North Campus Faculty Housing Phase II  
Project No. FM110407L/986315

**Addendum No. 6**

ADDENDUM NUMBER 6  
to the  
CONSTRUCTION DOCUMENTS

BUILDING 600A REVERSE : SECTIONS 2

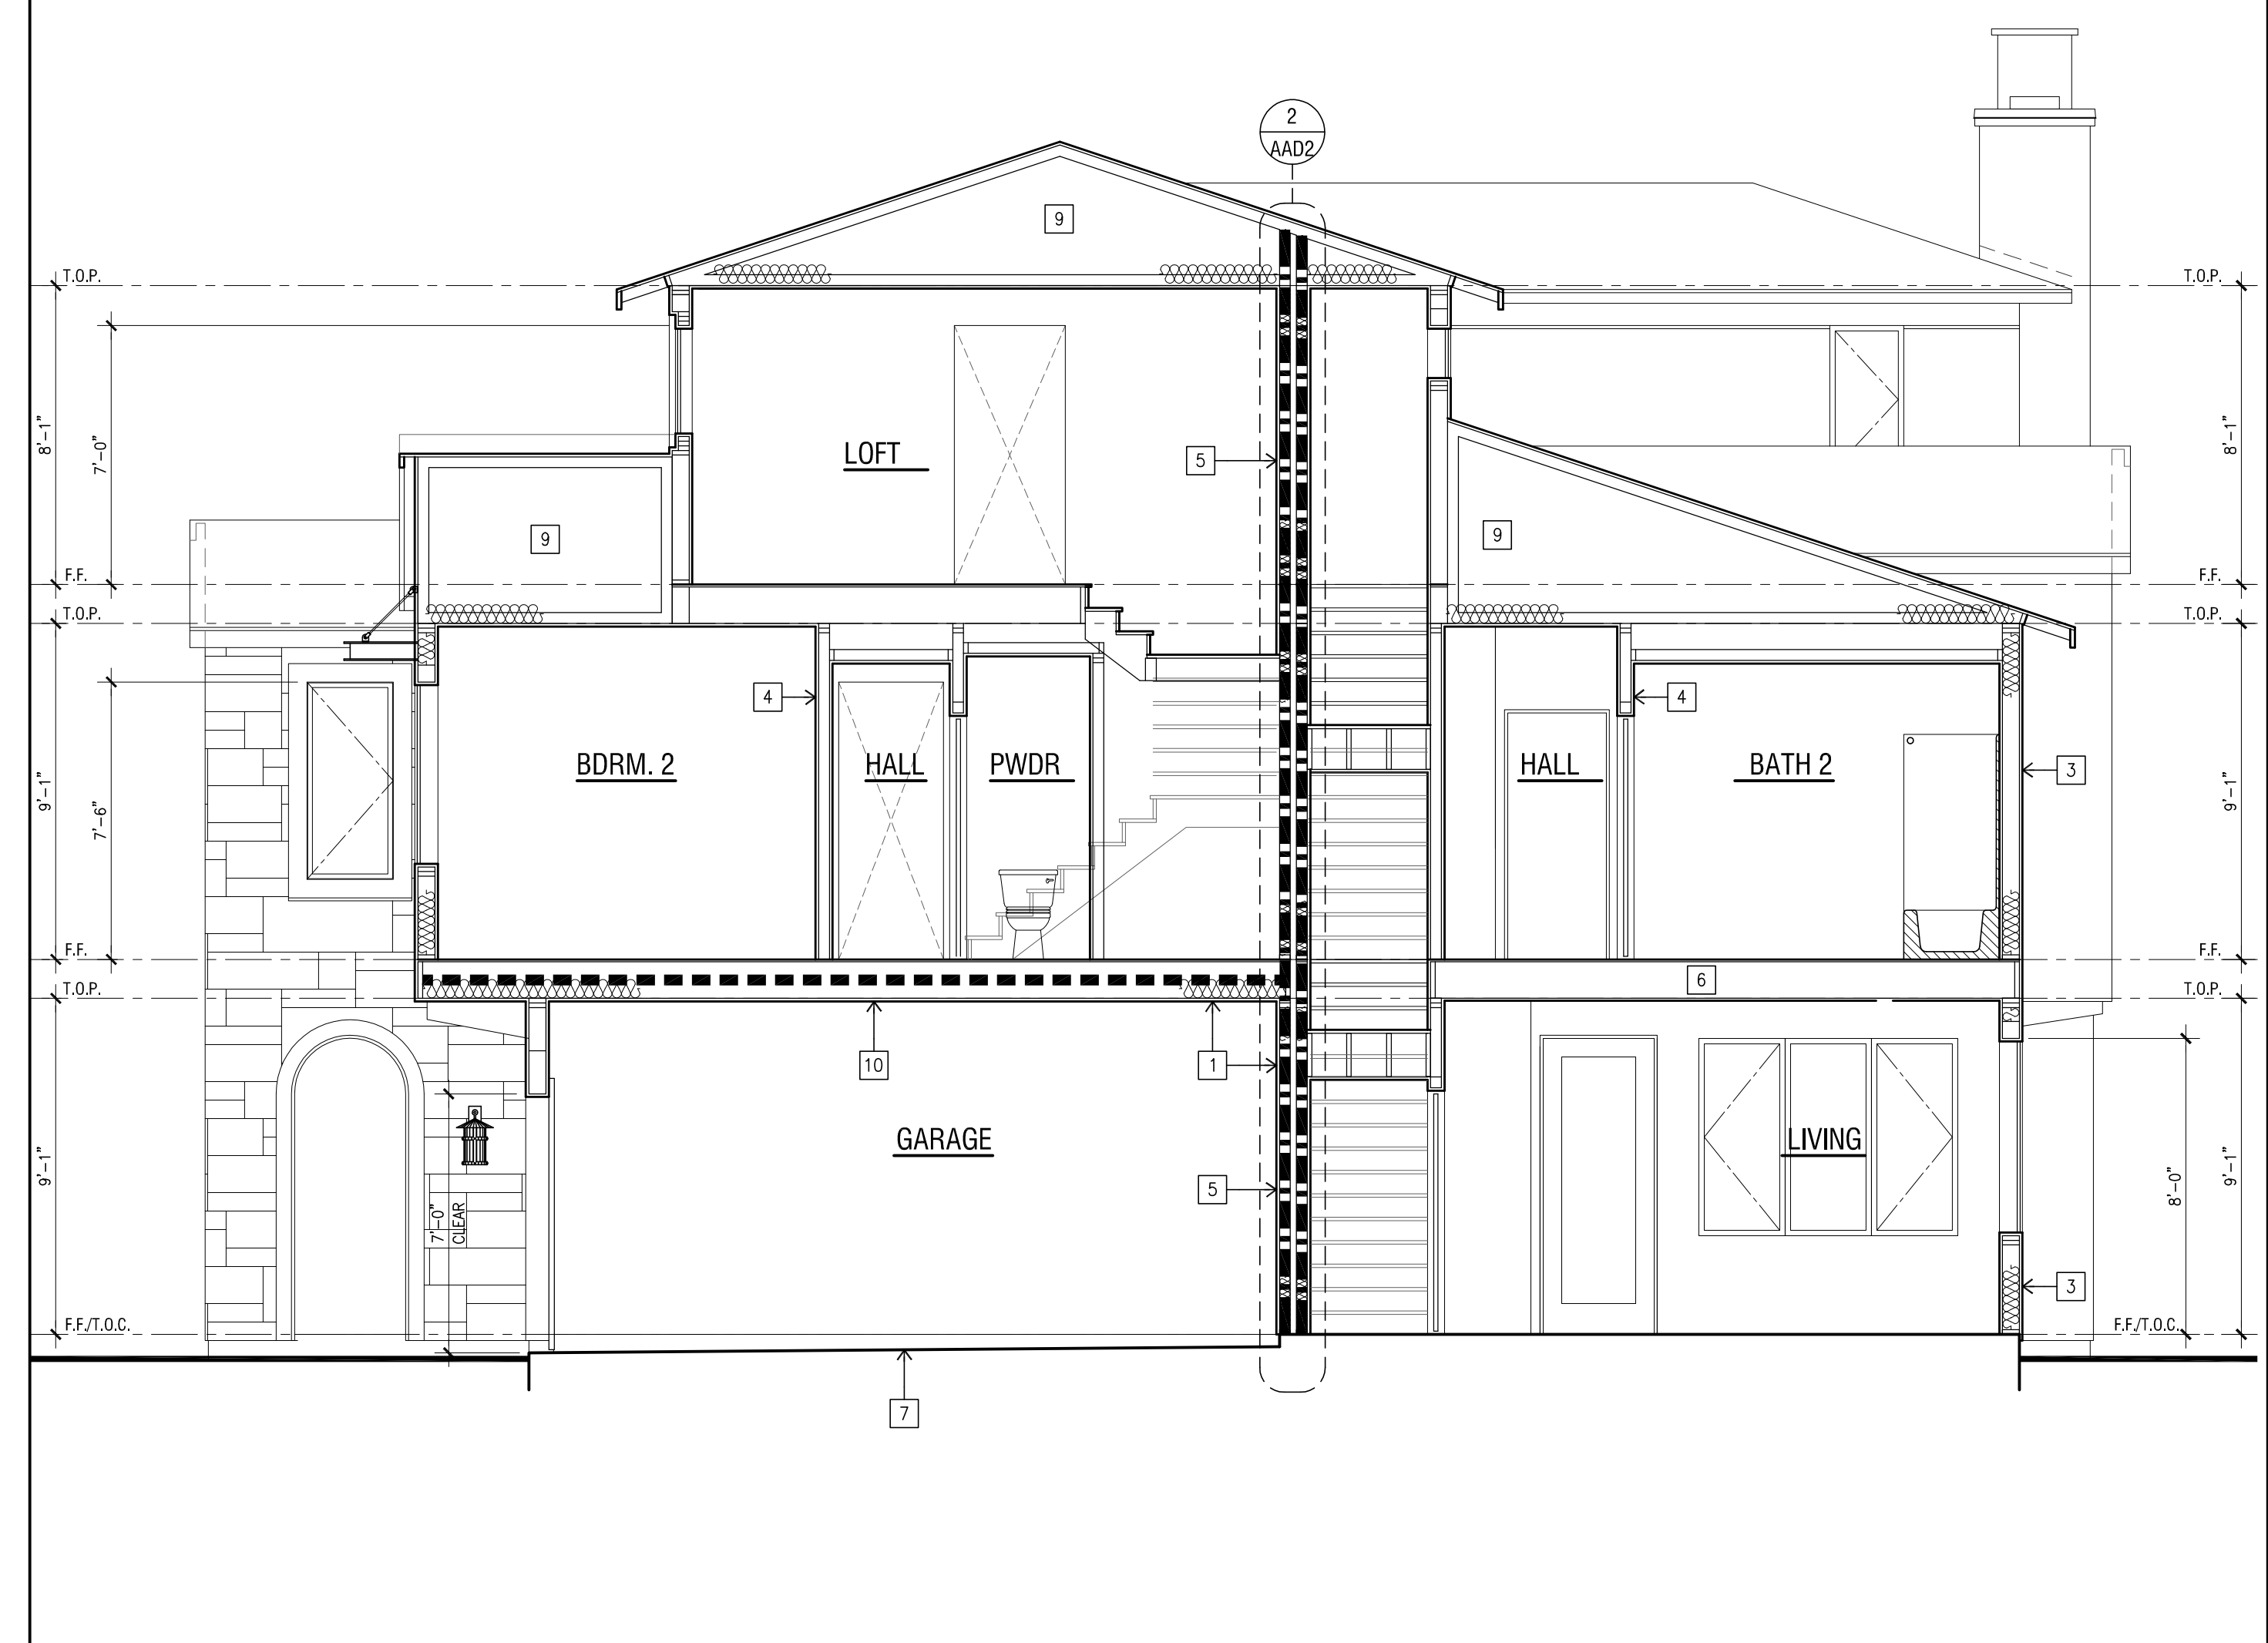
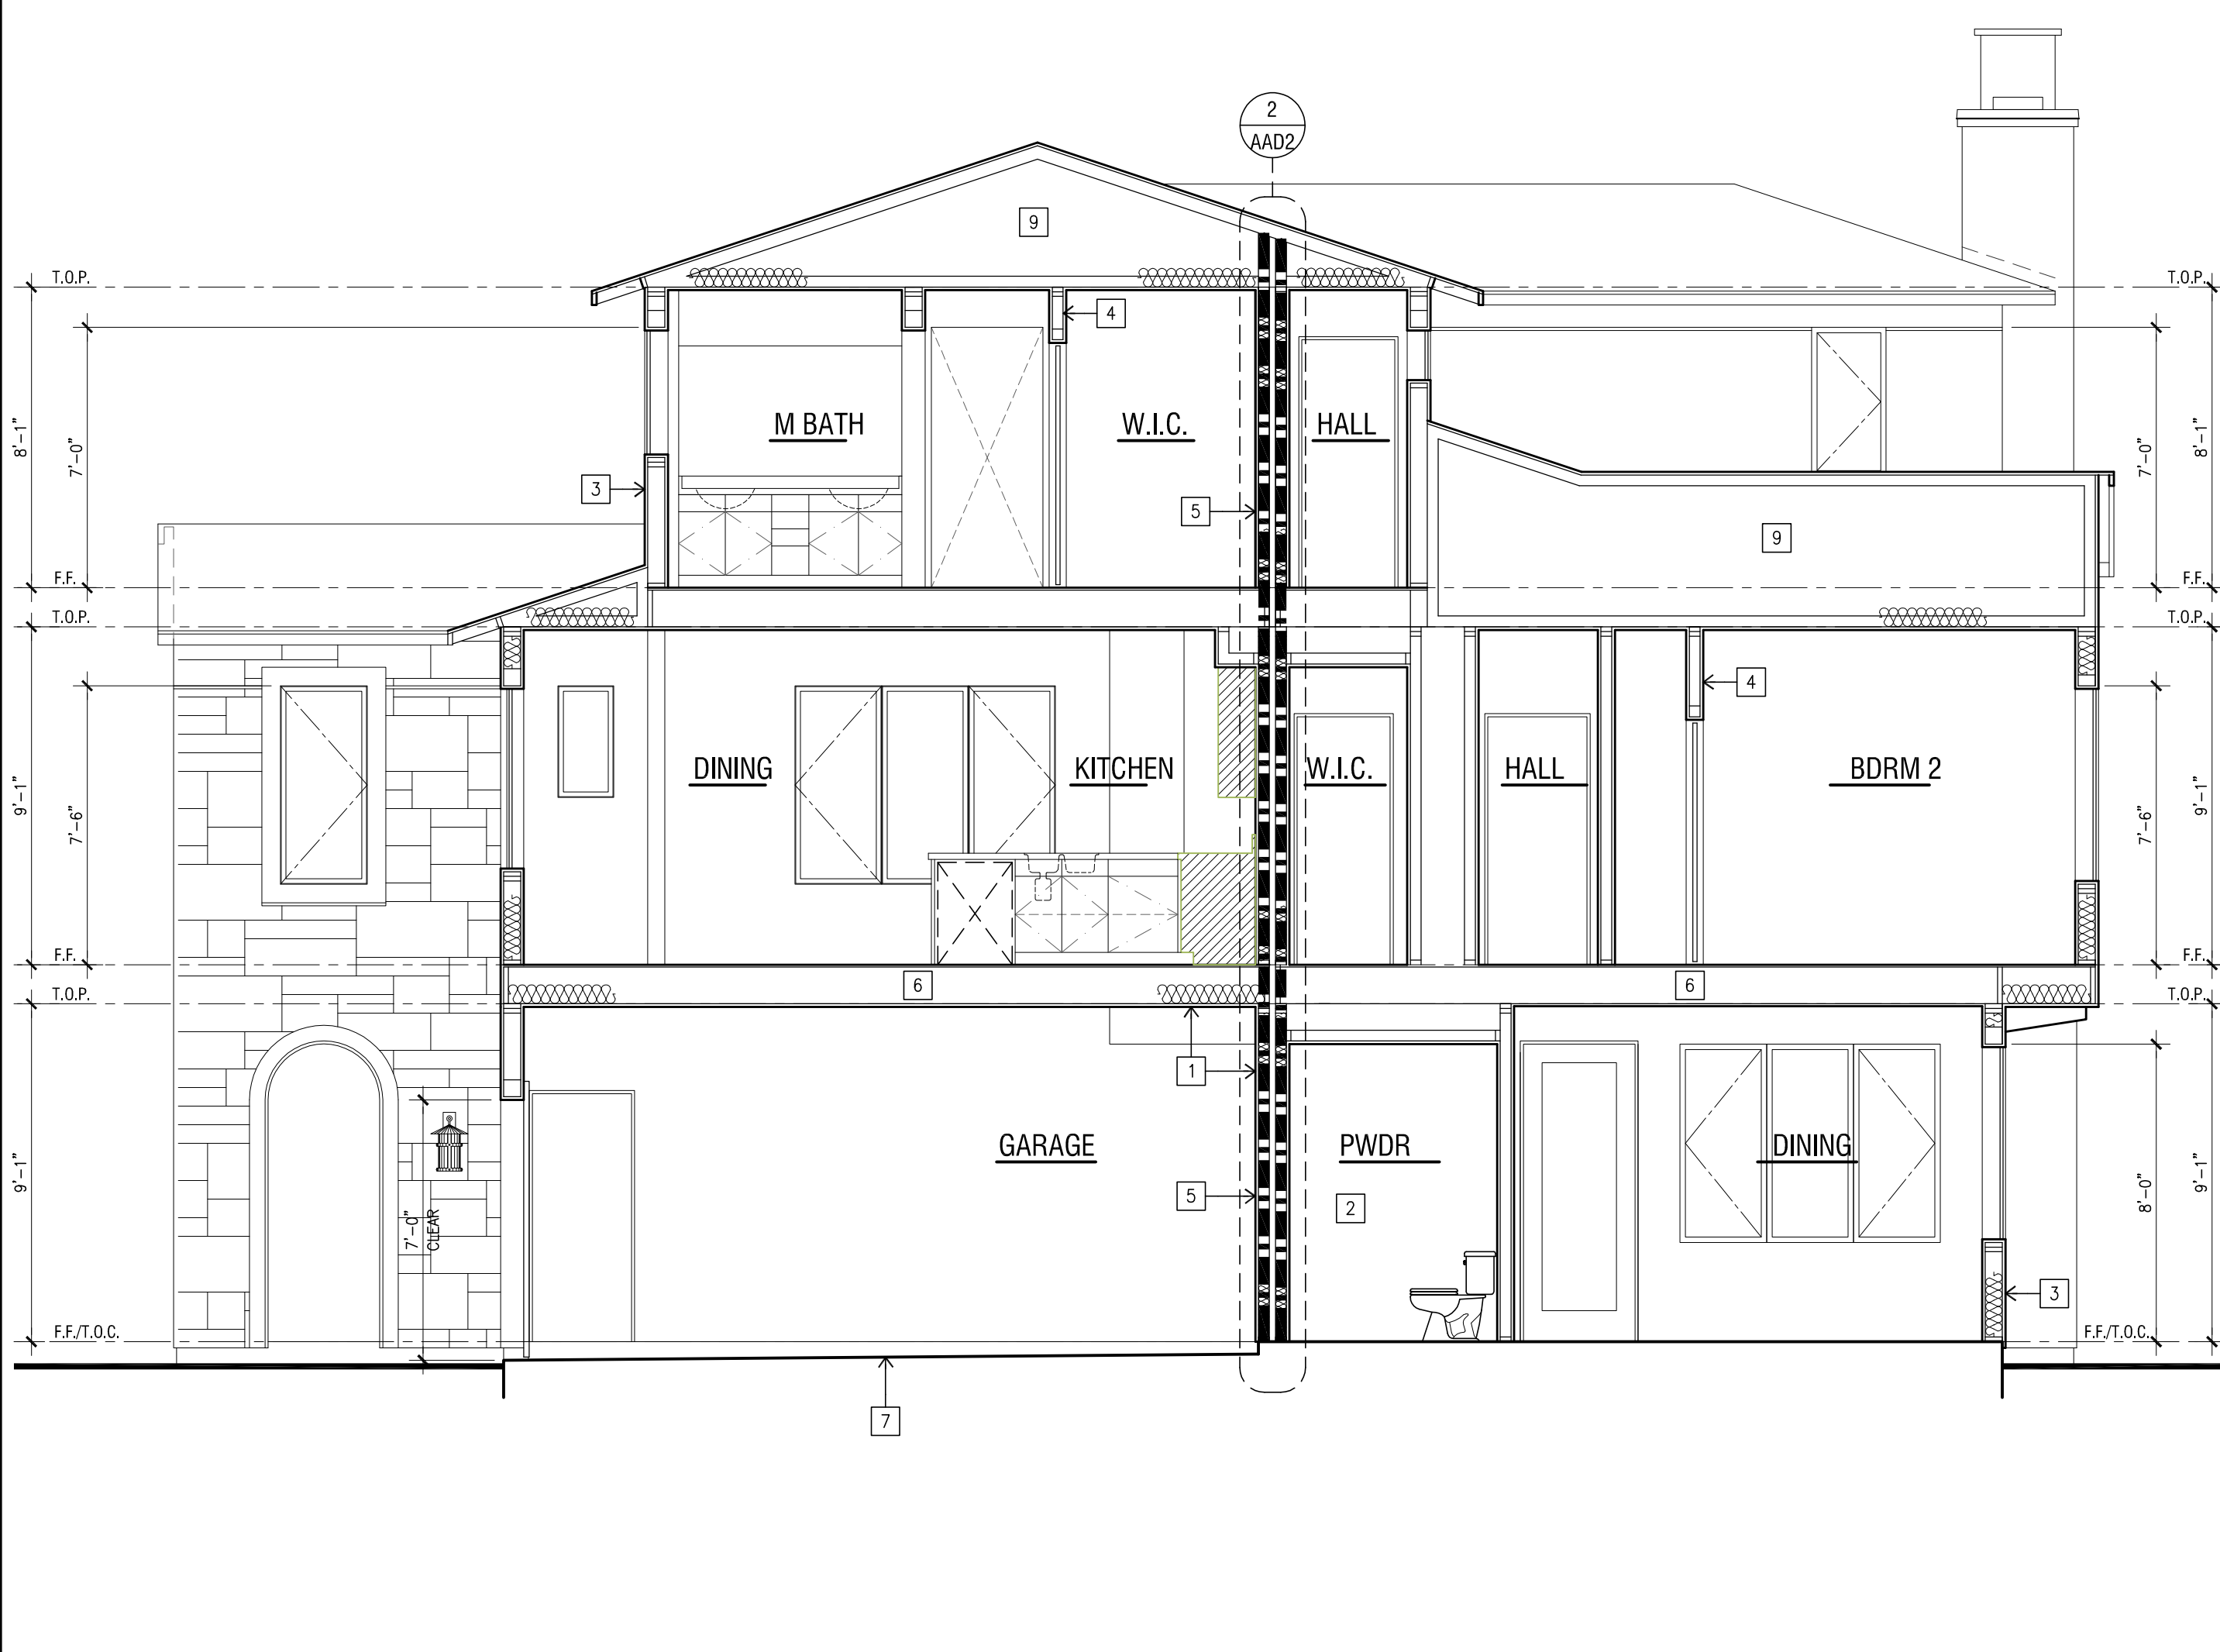
Sketch 5 of 8	Building 600A: Reverse: Sections
Sketch 6 of 8	Building 600B: Sections
Sketch 7 of 8	Building 700A: Sections
Sketch 8 of 8	Building 700A: Reverse: Sections
